MITSUBISHI MU-2 AIRPLANES; Availability of Special Certification Review

Subject: ACTION: Mitsubishi MU-2 Special Certification
Review (SCR) Program

SPECIAL CERTIFICATION REVIEW OF MITSUBISHI MU-2

FINAL REPORT

A photo and sketch of the calibration ramp is shown below:

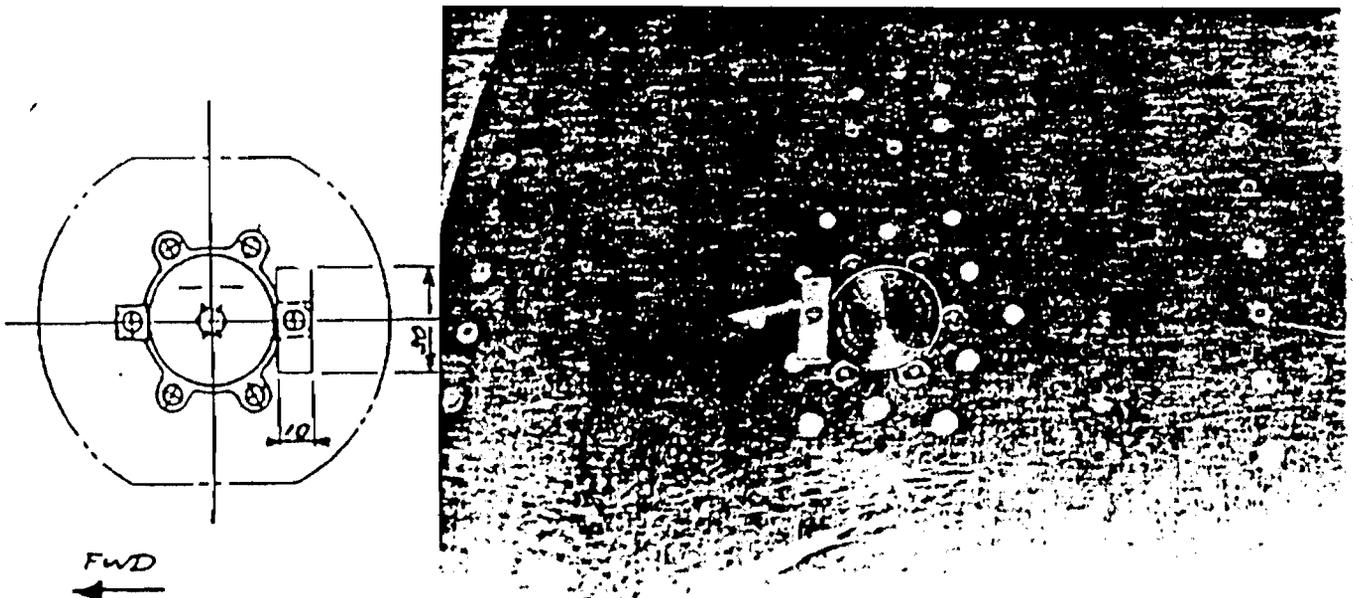
On all MU-2 airplanes, review any static pressure adjustment made by the method of attaching a metal spacer to the external surface of the airplane aft of the static port. Determine the adequacy of the static port ice protection system to prevent ice buildup as a result of the spacer.

Use of a static port calibration ramp to calibrate an aircraft static system is not a new or novel idea. NA265-40, HS-125, and some Lear models, to name a few, utilize static port calibration ramps.

We know of no service difficulty reports due to static port calibration ramp installations or of ice accretions on the ramps. The MU-2 mounted ramp is attached with a screw that is connected directly to the heated port, and it is reasonable to believe that there is a level of thermal conductivity between the static port and the calibration ramp. In addition, the calibration ramp is within the boundary layer of the fuselage and, therefore, should be considered ice accretion free.

Static and pitot sumps and drains
Right side MU-2-40

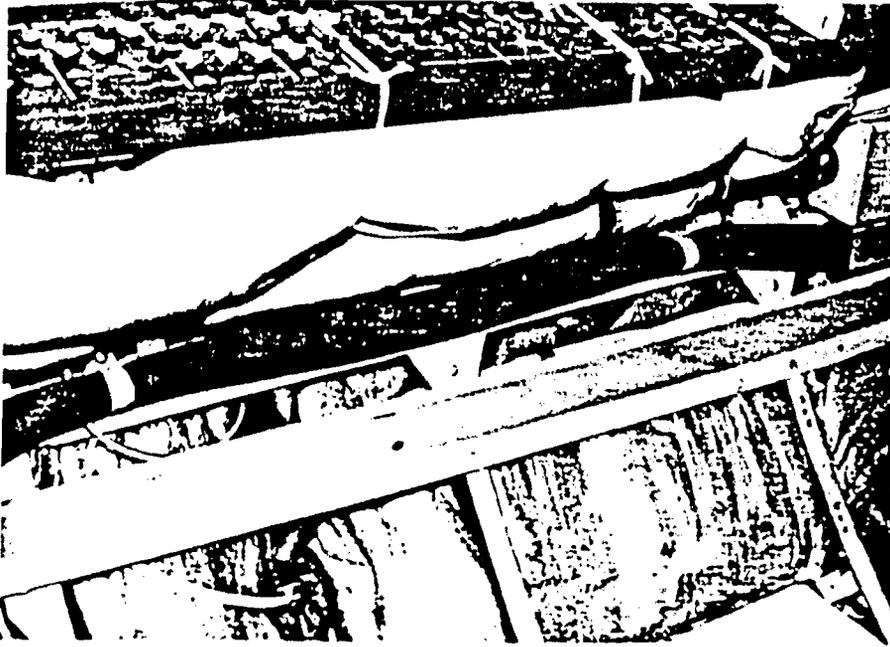
On all MU-2 airplanes, review the pitot pressure and static pressure system designs to determine if the designs are vulnerable to moisture accumulation and entrapment which may cause system pressure blockage particularly when the moisture freezes.

All pitot system plumbing is also located in the conditioned air (heated) side of the fuselage. As can be seen on the photos below, the pitot pressure line enters the fuselage and immediately goes "downhill" into a "T" fitting and into a moisture trap with a capacity of 6.6 cc for the RH trap and 6.2 cc for the LH trap.

During MEOT Flight SCR-20-30 on February 9, 1984, the aircraft was flown through moisture and through a moderate to heavy 45-minute icing encounter. Four-five inches of ice were accreted on unprotected surfaces. No anomalies in the pitot/static system were reported. After the flight, the system drains were opened and no moisture was detected. In addition, Mitsubishi conducted a random field study to determine if moisture was trapped in the pitot/static system. Out of 37 airplanes checked, only three were found to have trapped moisture in the sumps with six drops being the maximum found.

Mitsubishi has voluntarily committed themselves to revising the Aircraft Maintenance Manual to amplify the importance of draining the pitot/static system after flying through rain and in addition to keep covers on the pitot/static ports when washing the airplane. They are also planning to add a note in the flight manual instructing the pilot to inform maintenance personnel when the aircraft has been flown through heavy rain.

No further action is planned.

Field Approved Alternate Static Source Selector Location

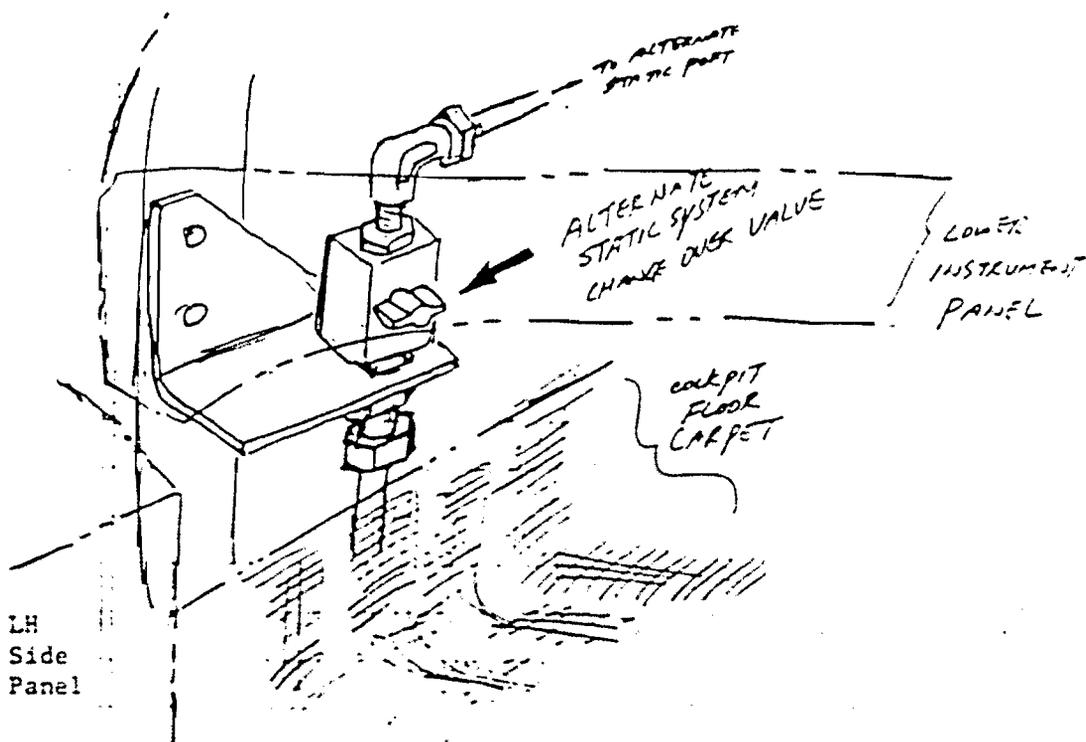
On all Model MU-2 airplanes, review the location and identification of the alternate static source controls. Determine if the alternate static source control is sufficiently accessible and properly identified to the pilot. Review must consider the loss of the primary static system or function during critical portions of a flight and the selection of the alternate static is required.

The other alternate static system that may be installed on the MU-2 was a "field approved" installation. The location of this alternate static source selector is on the left side panel close to the left-hand corner of the lower instrument panel. See sketches of the installation.

Both alternate static system designs have been reviewed and are found to be airworthy. However, during the SCR team review at least five airplanes with the field approved alternate static system with field approved interiors were found, after aircraft delivery, to have the alternate source selector covered with wire bundles or interior materials.

Conclusion: The field approved and type design alternate static systems have been reviewed and determined to meet airworthy standards. However, information surfaced during the SCR investigation that points toward improper installations of interior or at least five airplanes subsequent to aircraft leaving the Mitsubishi factory.

Since this is a maintenance induced problem, on an FAR 21.29 airplane, we recommend that the Small Airplane Certification Directorate work with the appropriate Flight Standards Office to have the condition corrected.

ELECTRICAL SYSTEM SCHEMATIC

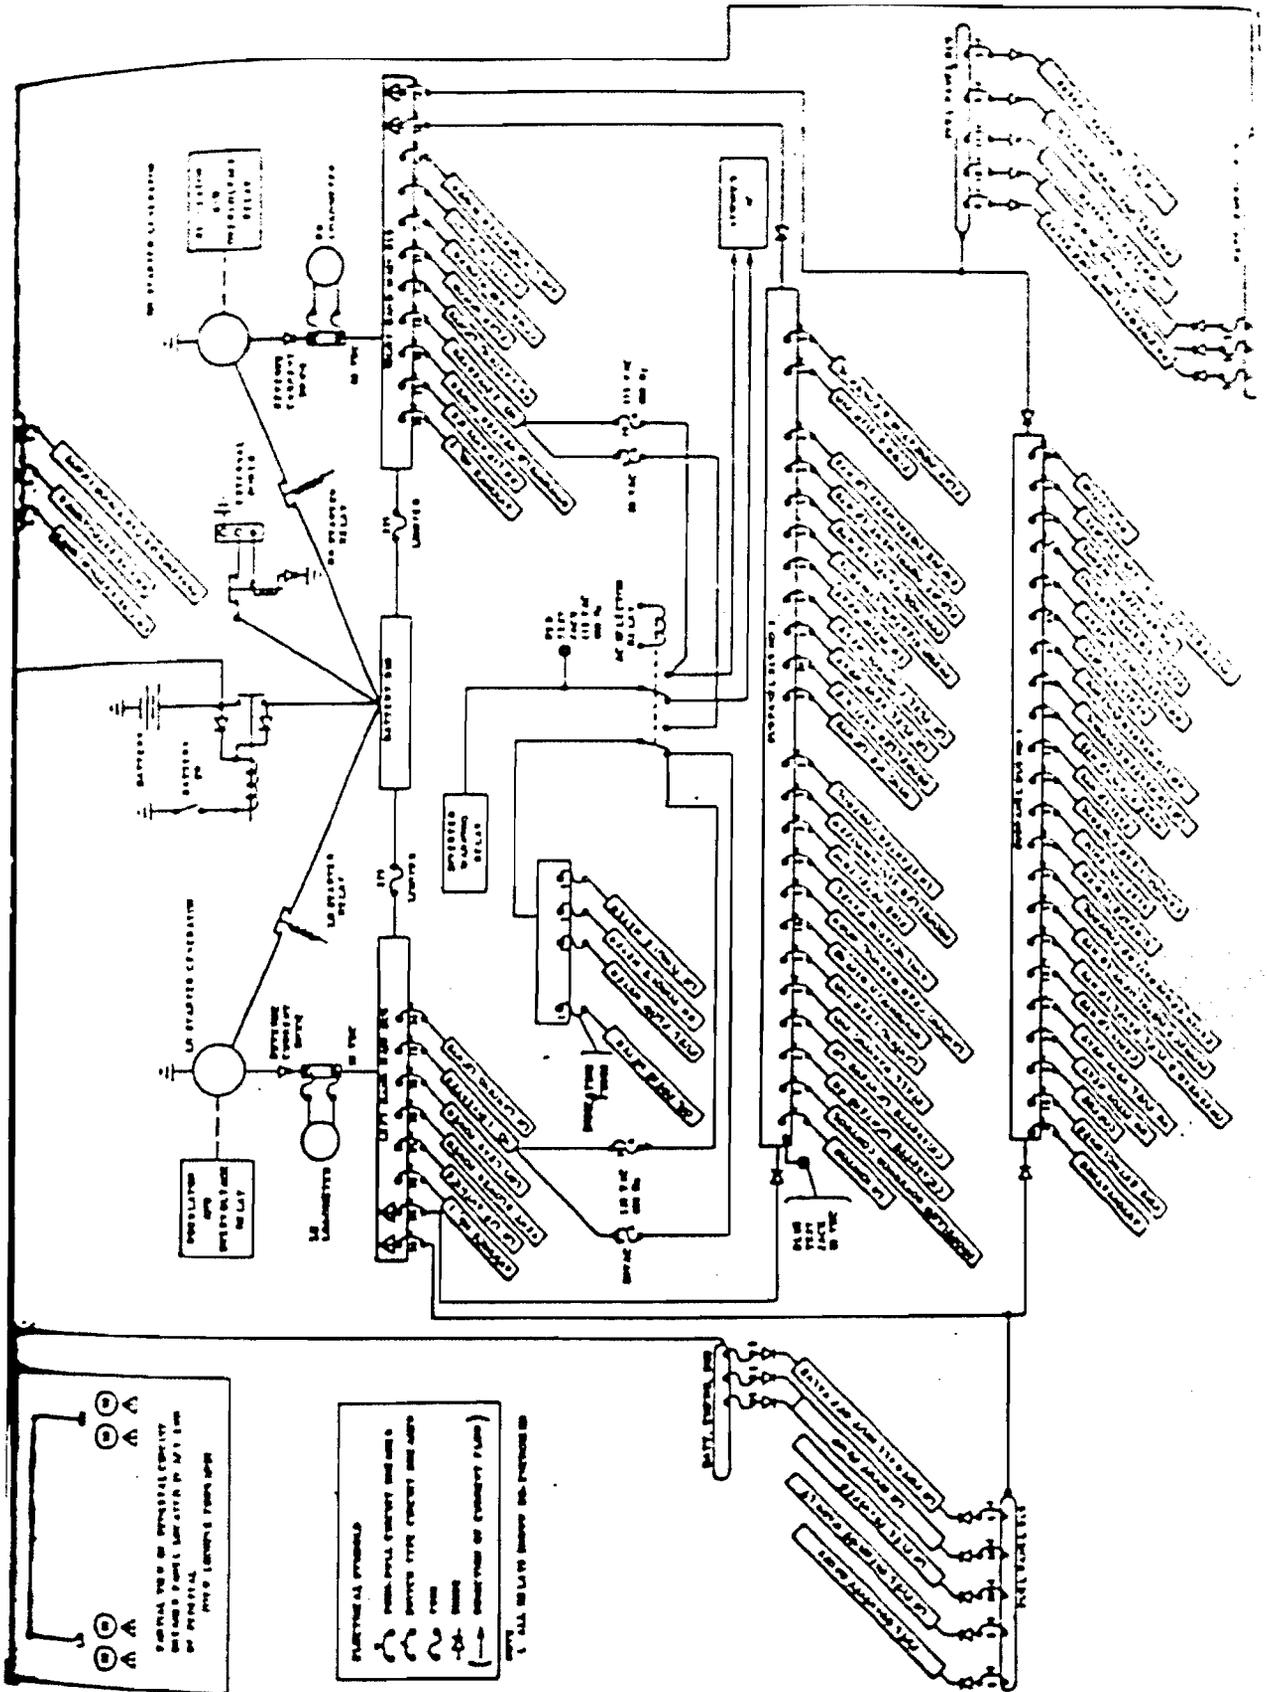
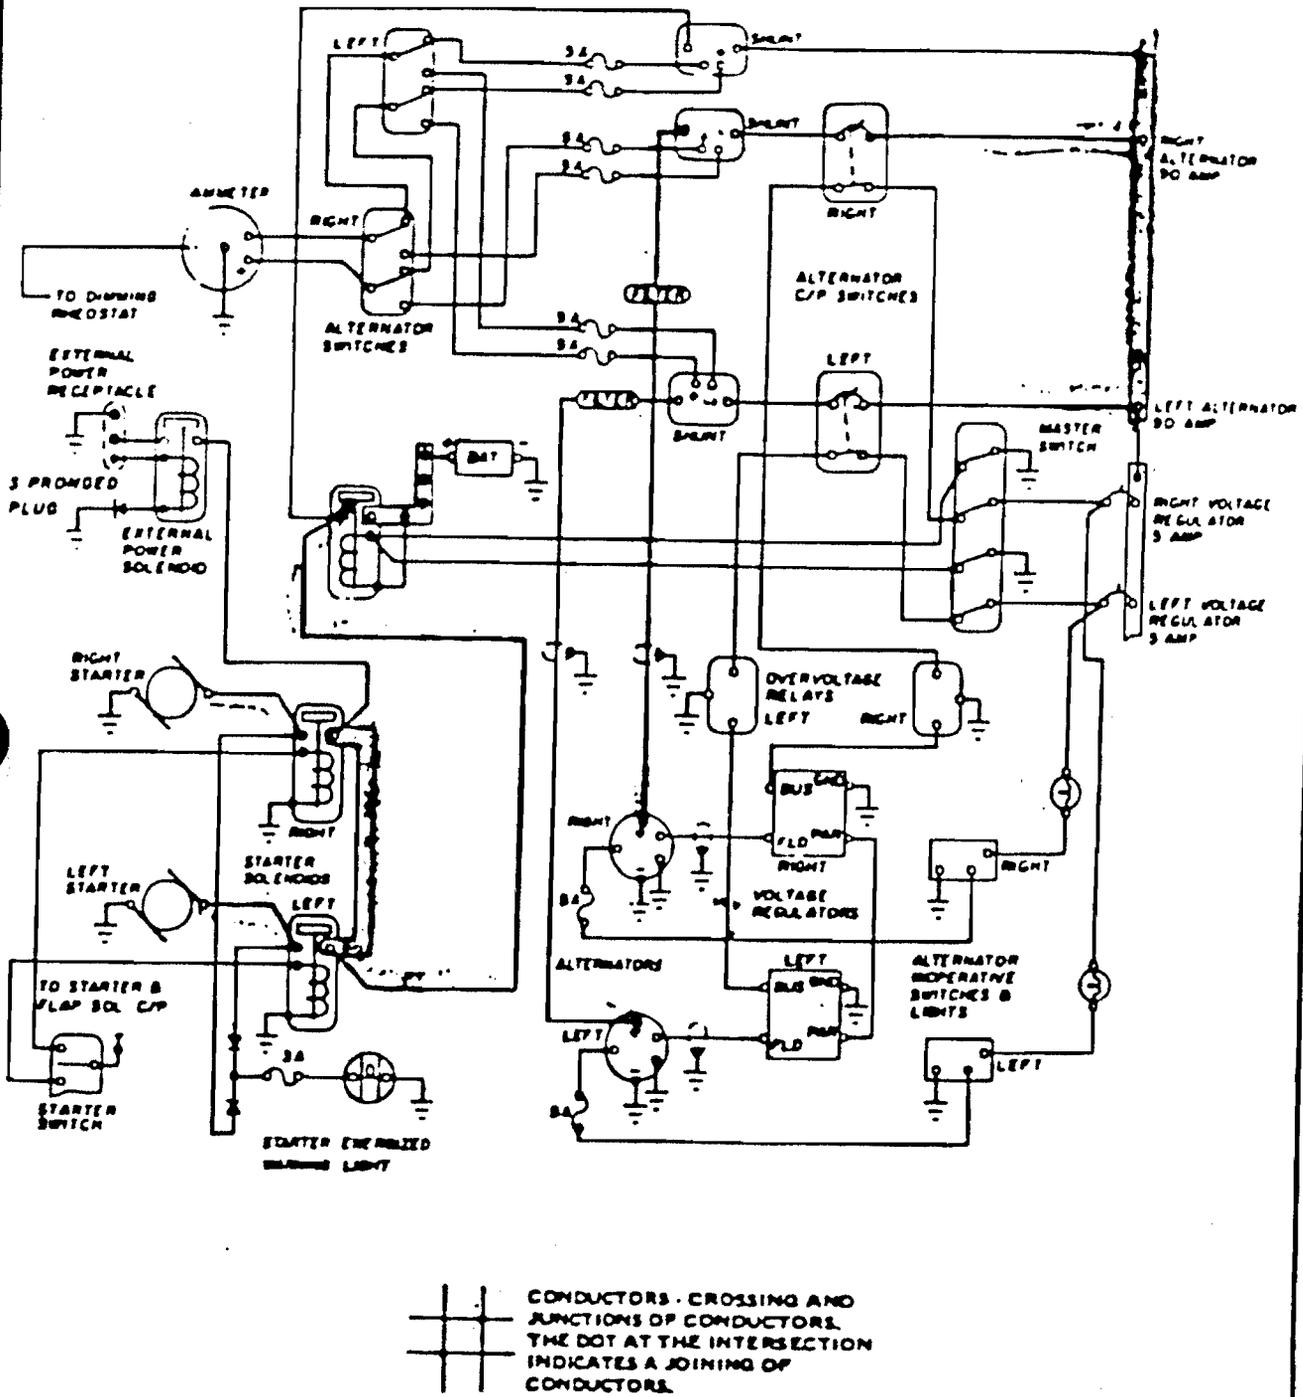
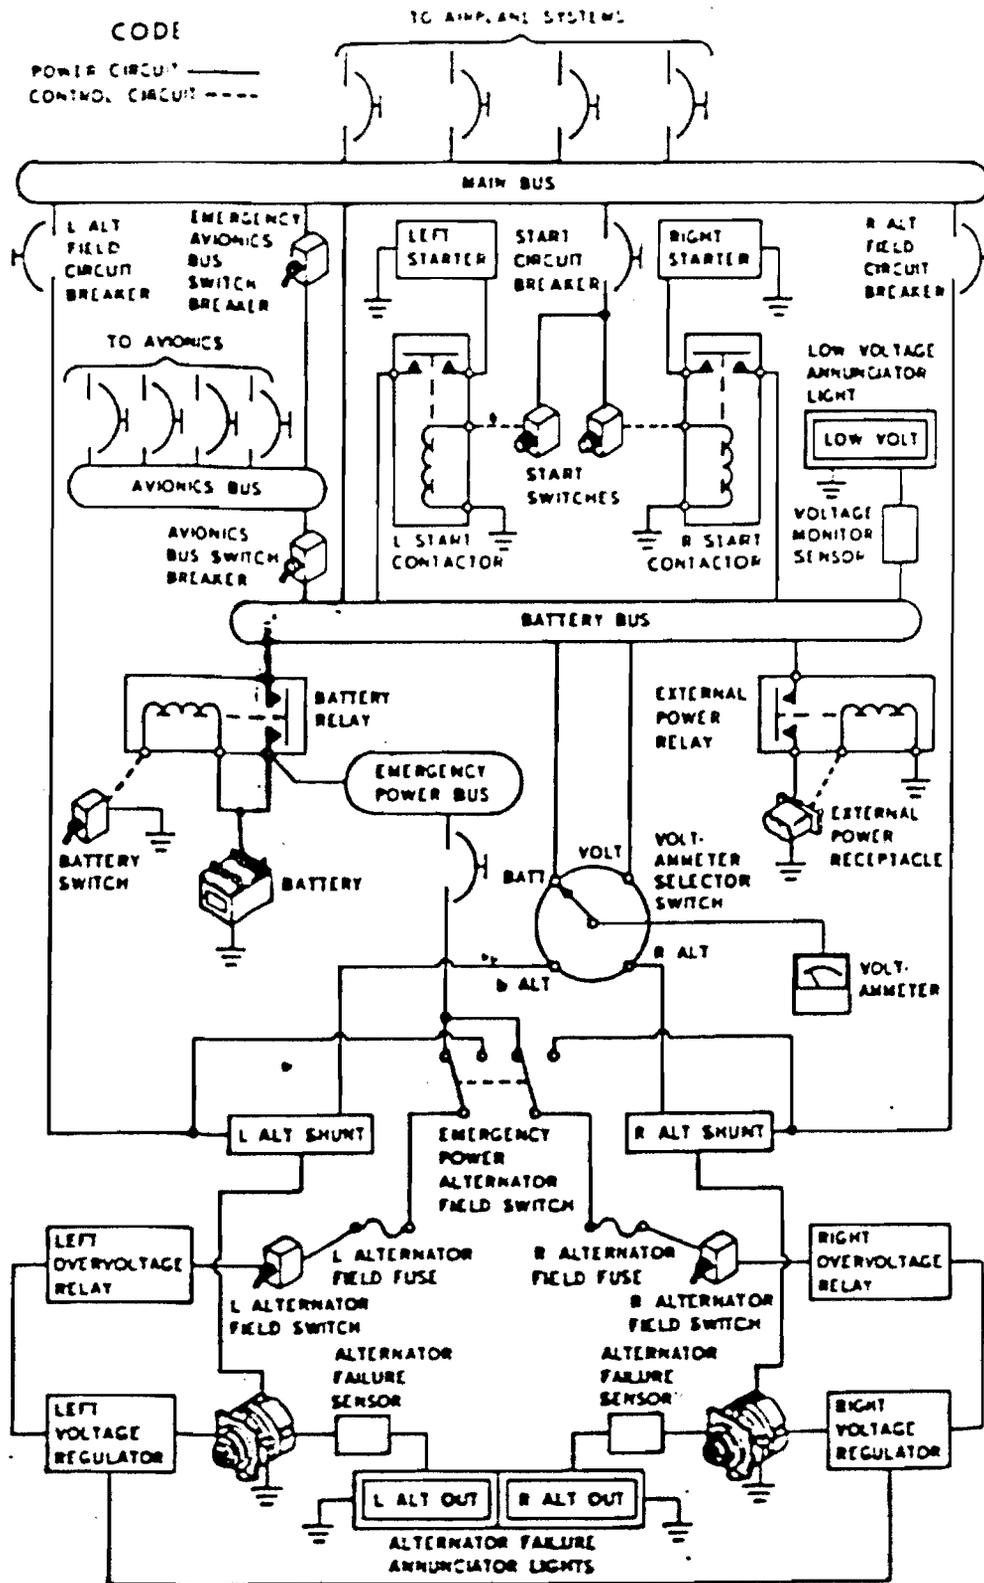
1. All MU-2 FAR 21.21 airplanes have a split bus and feeder fault protection. Of the A2PC airplanes, the MU2B-30, S/N 502 through 547, and the MU2B-35, S/N 586 and up, have a split bus and feeder current limiters and all the MU2B-36 airplanes have a split bus and feeder fault protection. The remainder of the A2PC airplanes have a single bus with no feeder fault protection. At the time these earlier airplanes were certificated, the single bus with no feeder fault protection concept, with the proper attention given to routing of cables, isolation from flammable fluid, and selection of quality insulation materials was a design accepted as airworthy. The Cessna 414 and Piper PA-31 are typical examples of this vintage airplane which have a single bus and no feeder fault protection. The Beech King Air C90 has a split bus but also does not have feeder fault protection. Copies of the schematics of these airplanes are attached.

To this date, the service history of the electrical systems on these airplanes has shown them to be safe and reliable. Evidently, the finding was made when they were FAR 21.29 type certificated that the method of insulation and isolation design which was used when installing these systems enabled them to come under the CAR 3.690 category where protective devices need not be installed "where no hazard is presented by their omission."

We see no reason, at this time, to challenge the validity of that finding.

FIG 1. Circuit Breaker Panel Arrangement (See TABLE 1)

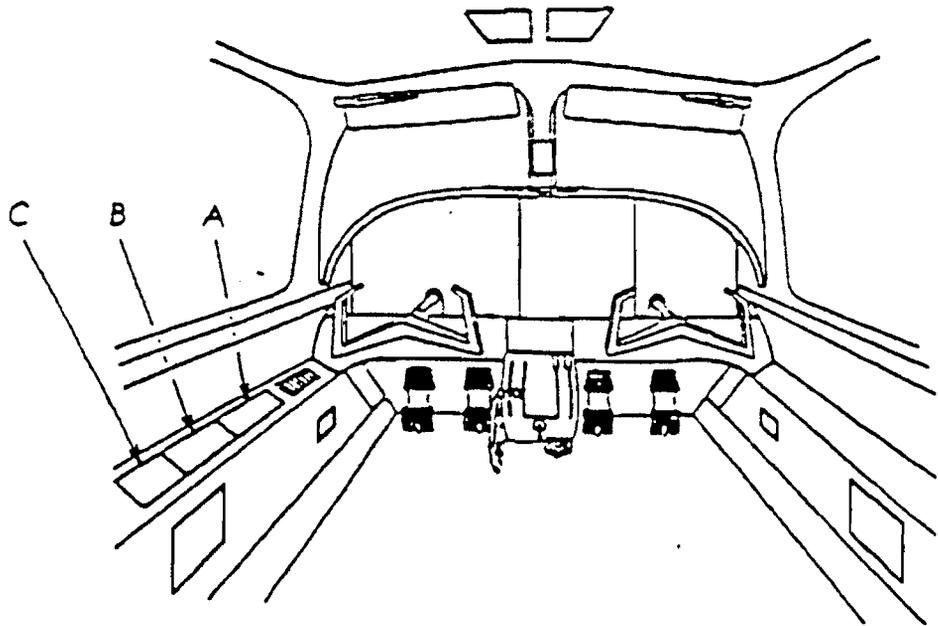
As shown on following pages, all circuit breaker panels are proper marking and grouping.
